Access Compliance Report

Public Rights-of-Way

Intersection ID: 50618	Main Street: YELLOW_OAK_RD	Cross Street: ABNEY_CT	Location: S
ADA ID: B59E588176E3	Ramp Type: Perp	Initial Pass/Fail: Fail	Overall Compliance: No
		Severity Score: 10

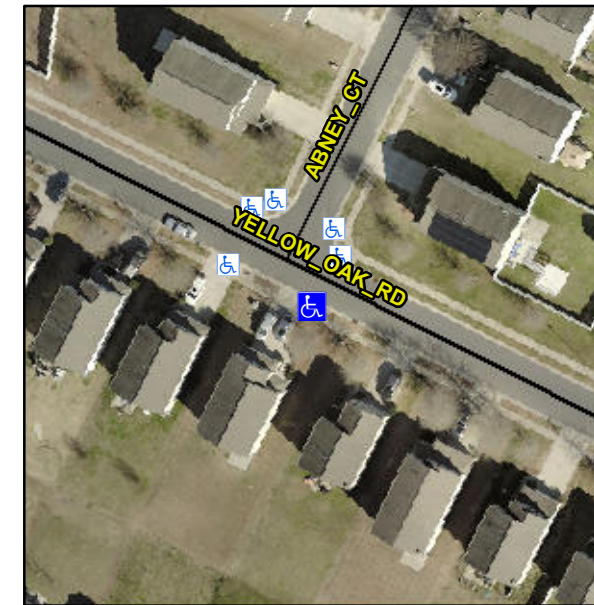
Not Found, R304.5.1, R304.5.3

Compliance	Description	Data	Compliance	Description	Data
N/A	Ramp Length (in)	48.0	Yes	Ramp Slope (%)	7.1
No	Ramp Width (in)	47.5	No	Ramp XSlope (%)	3.0
N/A	Flare Type LT	N/A	N/A	Flare Type RT	N/A
N/A	Flare Slope LT (%)	N/A	N/A	Flare Slope RT (%)	N/A
N/A	Flare Traversable LT?	N/A	N/A	Flare Traversable RT?	N/A
N/A	Landing Length (in)	N/A	N/A	DWS Provided?	N/A
N/A	Landing Width (in)	N/A	N/A	DWS Contrast?	N/A
N/A	Landing Slope (%)	N/A	N/A	DWS Length (in)	N/A
N/A	Landing X Slope (%)	N/A	N/A	DWS Full Width?	N/A
N/A	Landing Curb? (Y/N)	N/A	N/A	DWS Offset (in)	N/A
N/A	Shared Landing?	N/A			
N/A	Gutter Ponding?	N/A	N/A	Gutter Slope (%)	N/A
N/A	Gutter Lip Ht (in)	N/A	N/A	Gutter X Slope (%)	N/A
N/A	Painted X Walk1?	No	N/A	Painted X Walk2?	N/A
	X Walk 1 Direction	To NE		X Walk 2 Direction	N/A
N/A	X Walk 1 Width (in)	N/A	N/A	X Walk 2 Width (in)	N/A
	X Walk 1 Slope (%)	1.7		X Walk 2 Slope (%)	N/A
	X Walk 1 X Slope (%)	2.7		X Walk 2 X Slope (%)	N/A

Remove & Replace Entire Ramp.
